Lots 302 Mandurah Road and 309 Kerosene Lane, Baldivis

Addendum for the LWMS

By Urbaqua

March 2018

ATTACHMENT 3: Landscaping Plans

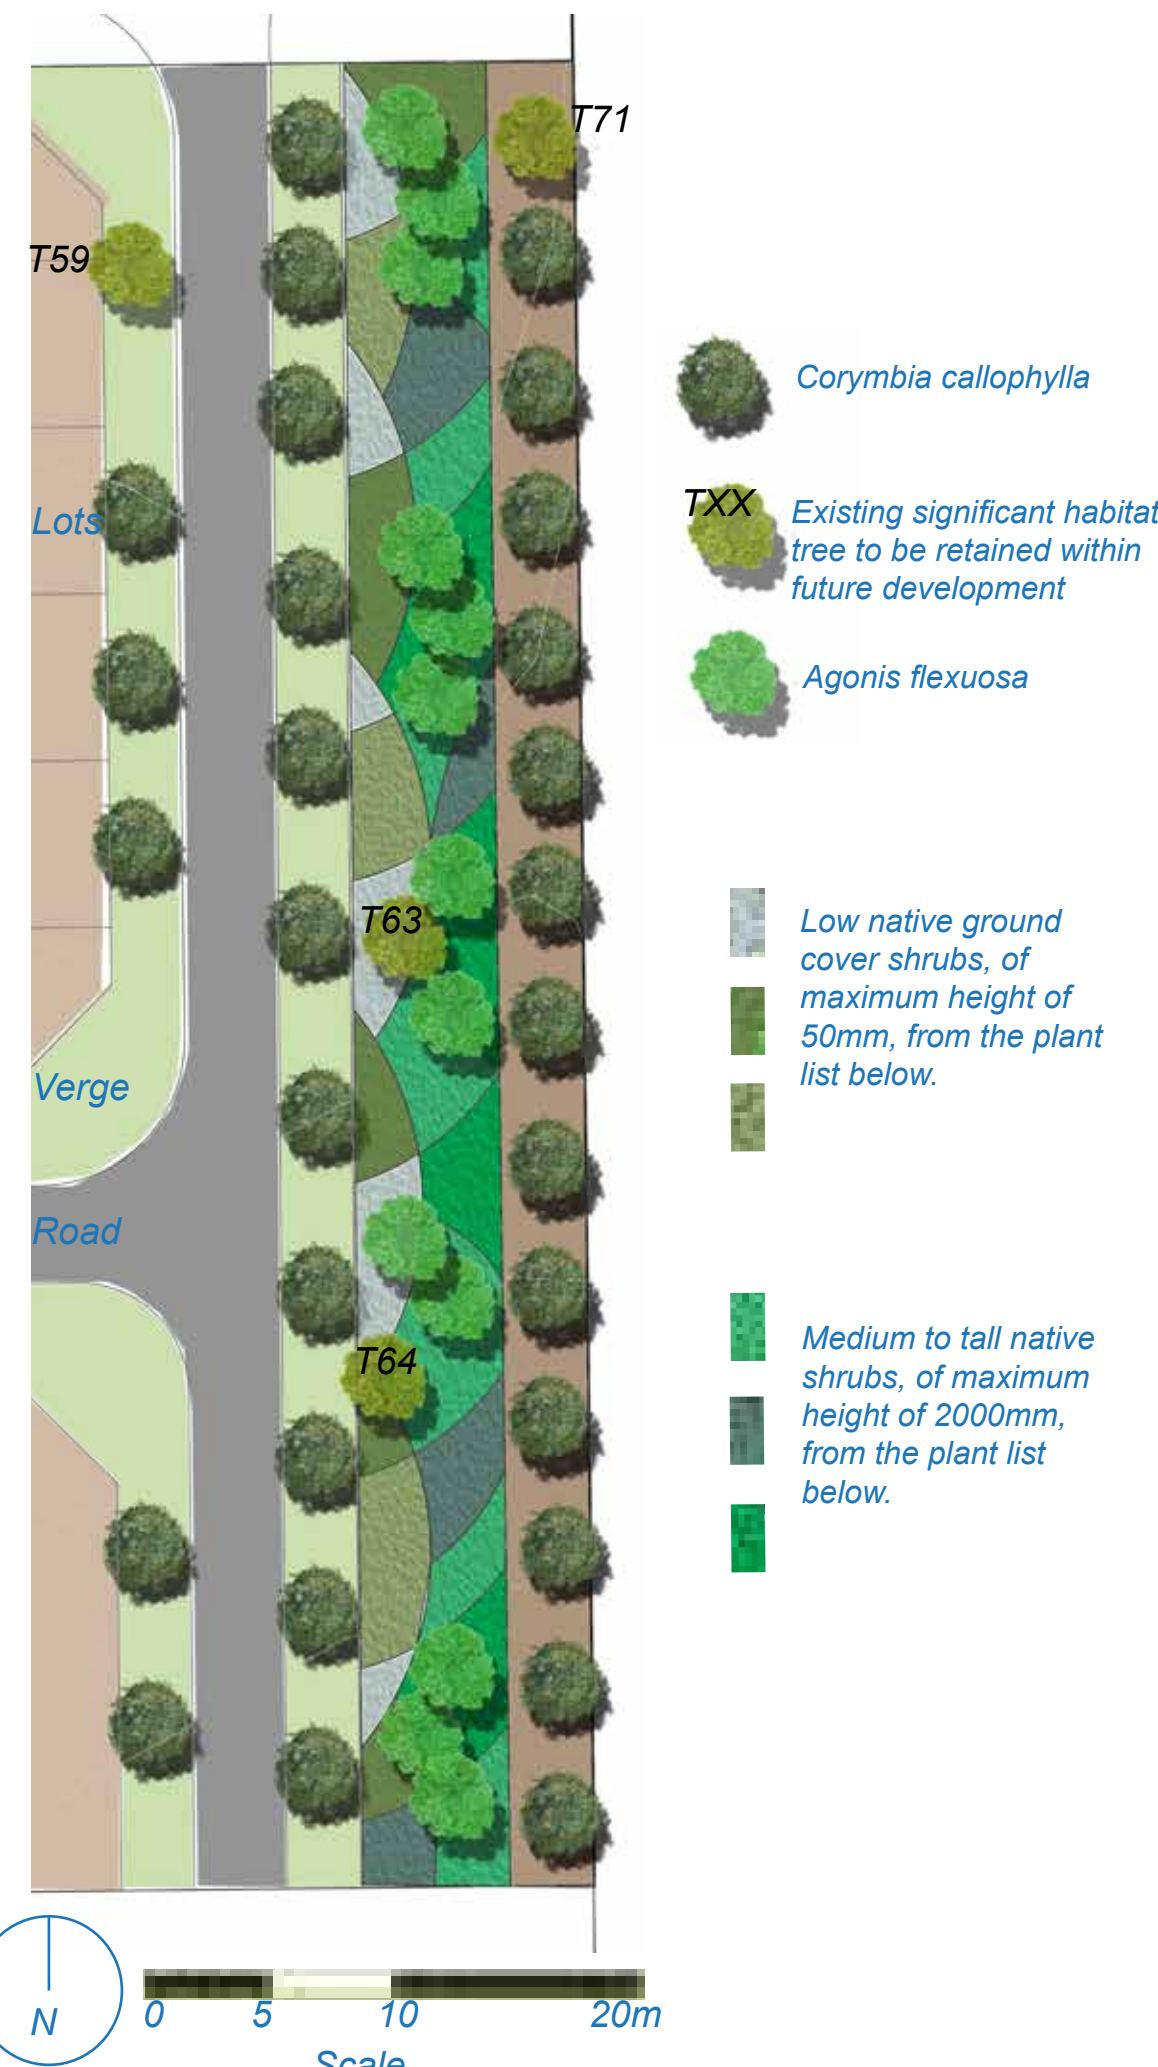
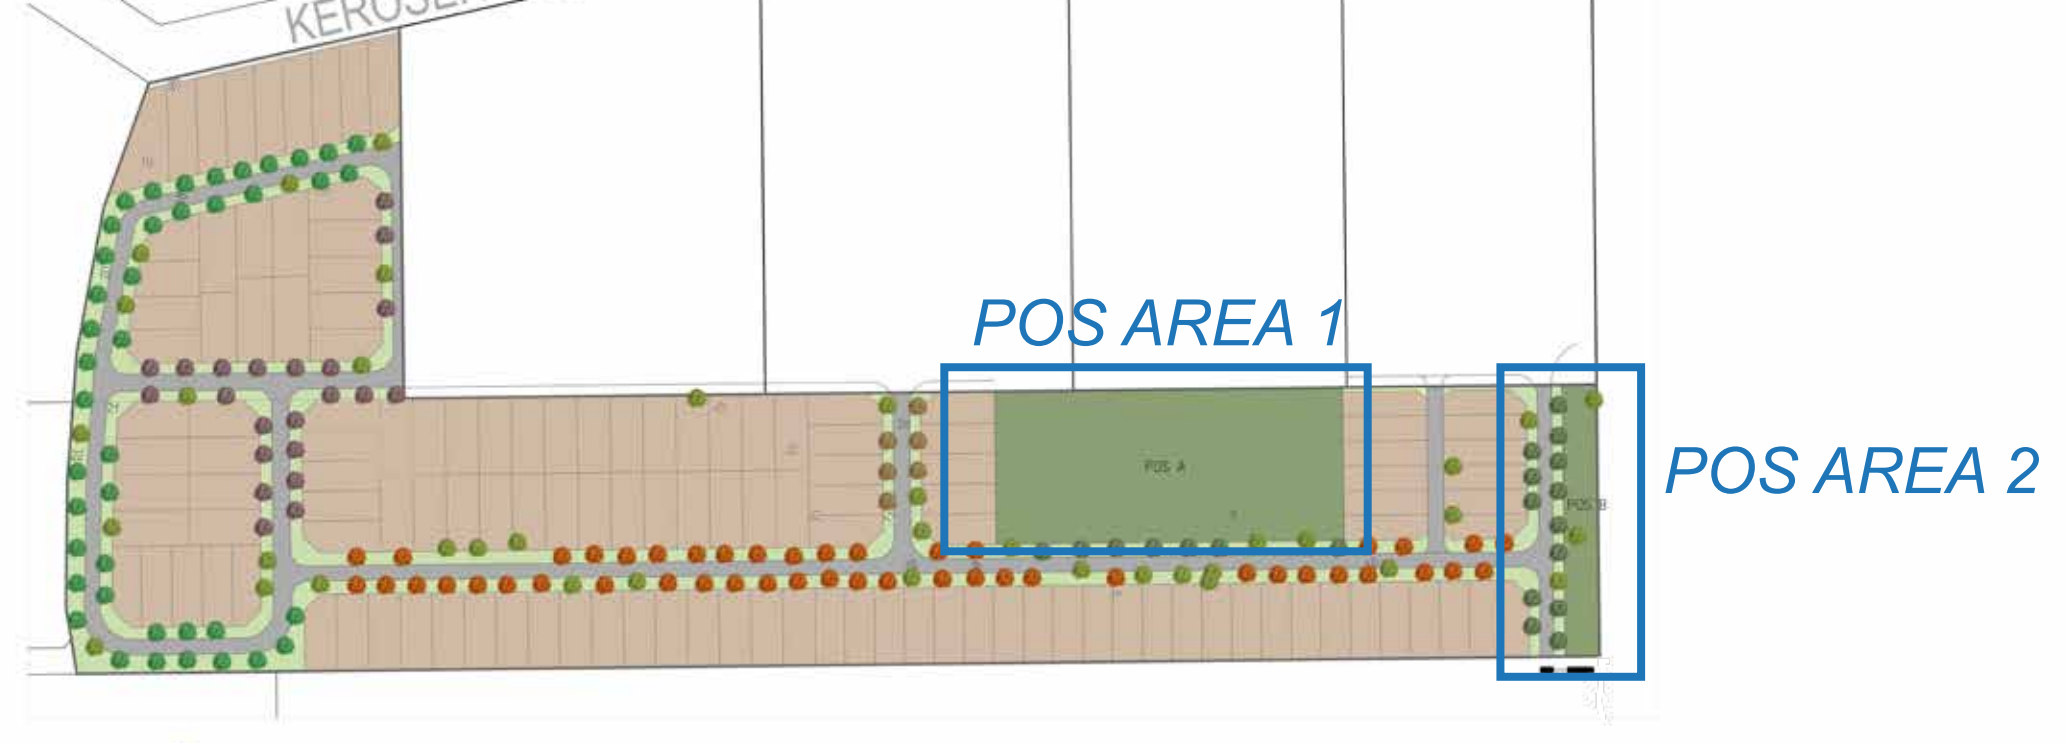
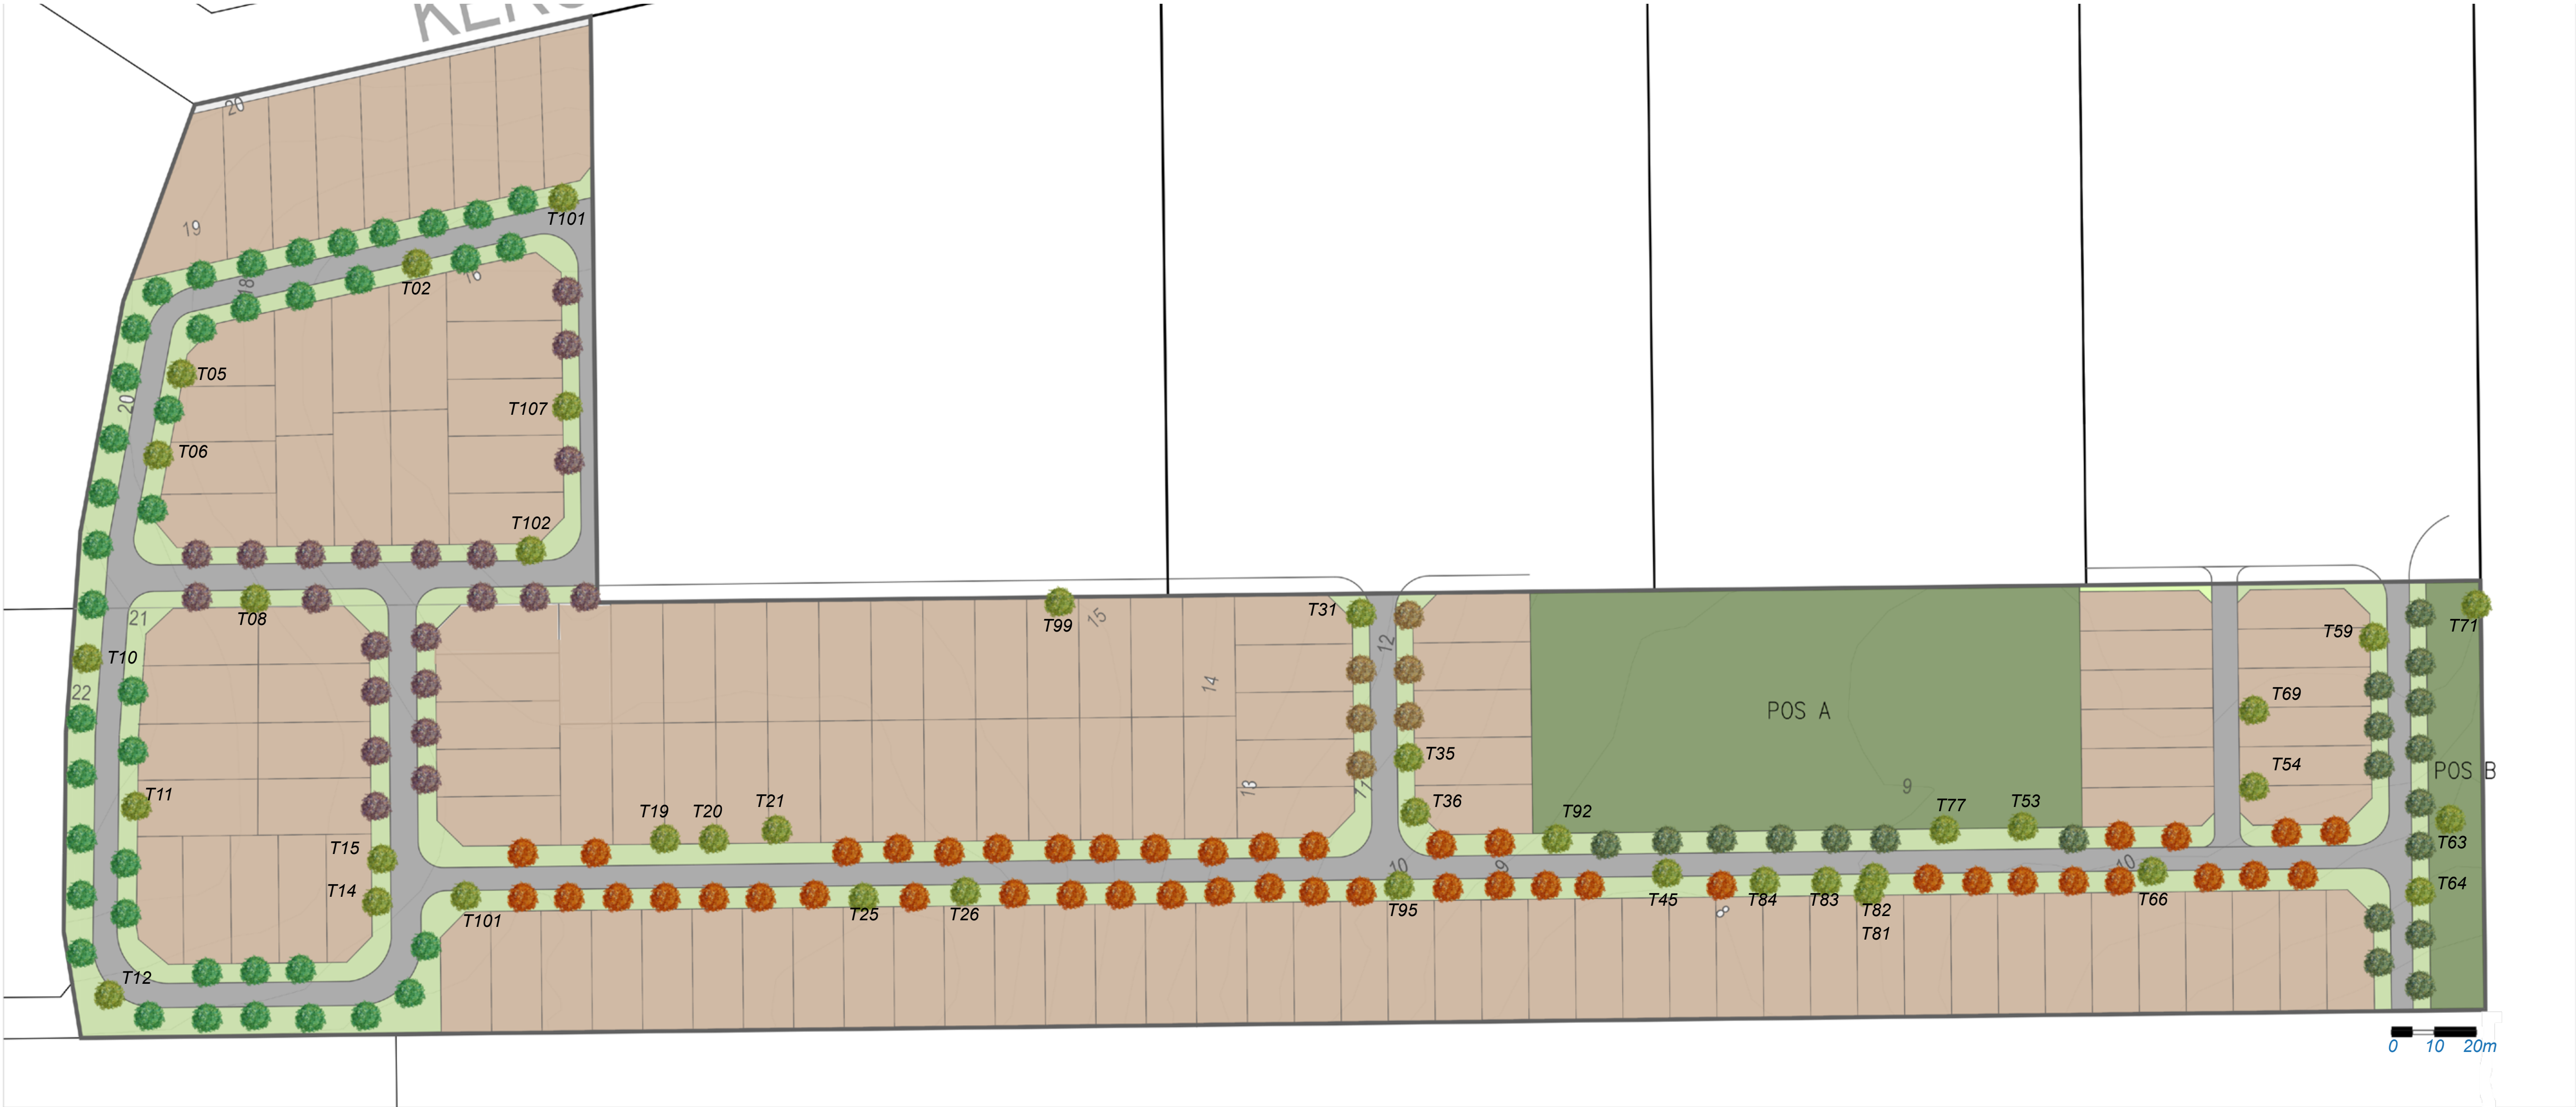
CoR	<p>Figure 9 has not been updated since the previous version of the LWMS and as such the information presented differs to that shown in Table 7. Figure 10 refers to an infiltration basin and area of inundation for the 1, 5 and 100 yr ARI. This should refer 1 EY, 20% and 1% AEP.</p> <p>Table 7 shows that the underground storage invert is the same as the storage basin invert of 9.0 mAHD. A conceptual cross section of the updated stormwater management configuration (underground storage and drainage basin) must be provided to demonstrate the intended design.</p> <p>A landscape concept is required to show how the stormwater management system will interact the POS design including existing vegetation/trees to be retained. The request for a Landscape Plan is outlined in Appendix A of the LWMS as a Better Urban Water Management (WAPC, 2008) requirement.</p>
DoW	<p>Diagrams indicated that the "1 yr ARI event" will be directed to surface bioretention area. All figures should be updated to reflect any revised stormwater runoff strategy.</p> <p>Please include a cross section of the proposed infiltration basin and include conceptual top water levels for all rainfall events, location and depth of amended soil, depth to groundwater and slope gradients. The cross section should indicate how the underground storage cells are integrated into the POS/stormwater runoff treatment system and detail preliminary dimensions, pipe connections and use of amended soils.</p>

Response	<p>Noted. Figures 9 and 10 had not been updated since the previous version of the LWMS.</p> <p>Hydrology and hydraulic modelling of the site has been undertaken with the latest IFDs and the infiltration rate of 5 m/day. Table 7 has been updated accordingly.</p> <p>Updated Figures 9 and 10 with a cross section as requested are provided in this addendum. A landscape concept is also provided in Attachment 3.</p>
